| PLANNING COMMITTEE | DATE: 15/12/2014 |
| REPORT OF THE SENIOR PLANNING AND ENVIRONMENT SERVICE MANAGER | DOLGELLAU |

Proposal: CONVERTING AN EMPTY BUILDING INTO AN AFFORDABLE HOUSE
 Location: BRYN LLYWELYN OUTBUILDING, TREGARTH, BANGOR, GWYNEDD, LL574PA

Summary of the Recommendation: TO REFUSE

Drawing No: 768.1A

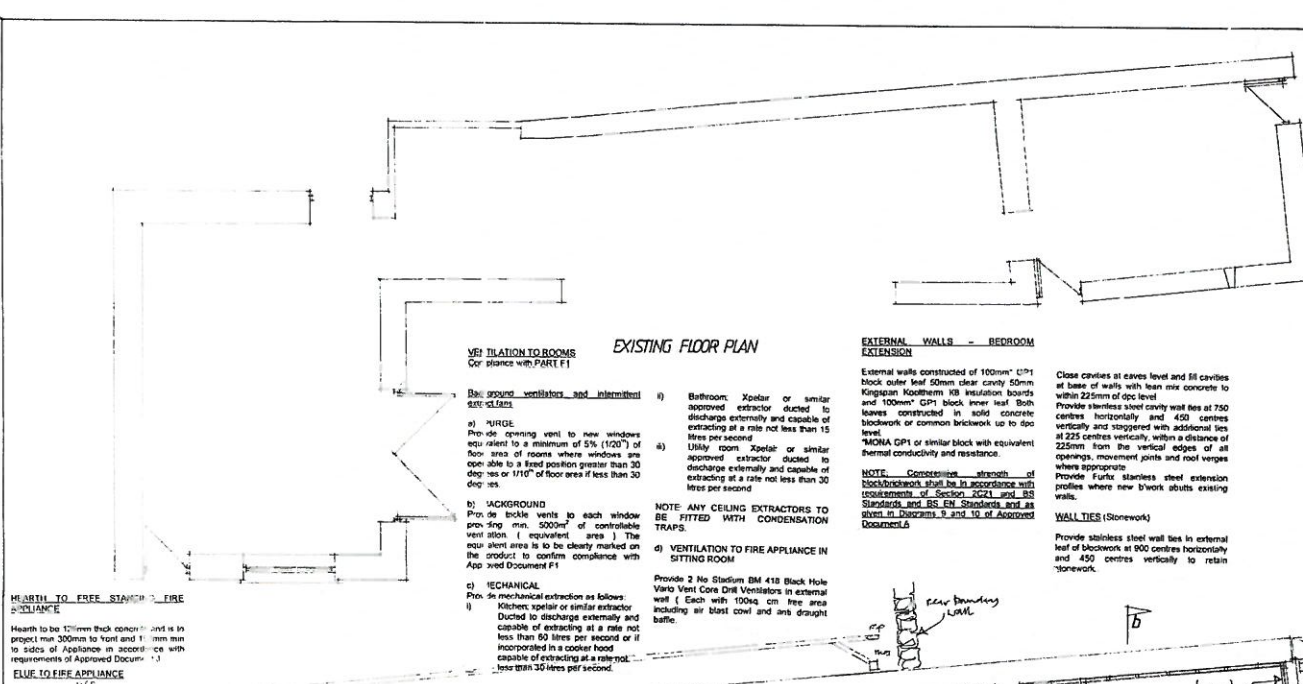
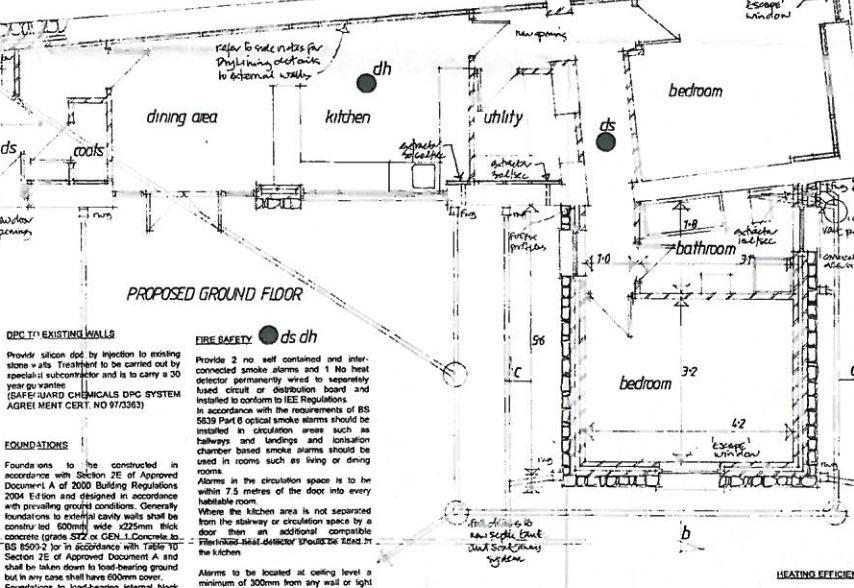
- 1.4 This proposal aims to combine current 'L' shaped agricultural buildings and erect an extension on part of the front of the buildings. Internally, this would provide a living/dining room, a kitchen, a utility room, two bedrooms and a bathroom. The application has been amended from its original submission by removing the windows that were shown to be installed on the back of the building.

- 5.1.8 It is seen in this case that a new extension is to be erected at the front of the current buildings that would provide a bathroom and a bedroom. This new extension measures around 21m², which brings the total surface area of the entire building to a little over 102m² on completion.

- 5.1.9 Additional to policy C4 is paragraph 5.16 of the SPG: Affordable Housing which notes that “the size of dwellings must not be excessive in relation to the size of the property that is required in order to meet the targeted need.” Following on from this, the SPG states that a maximum of 80m² would be an acceptable size for a single-storey two bedroom house. Due to the extension and the total surface area of this proposed house, it is believed that the proposal is unsuitable to provide an affordable house and therefore is contrary to the needs of policies C12, C4 and the Affordable Housing SPG.
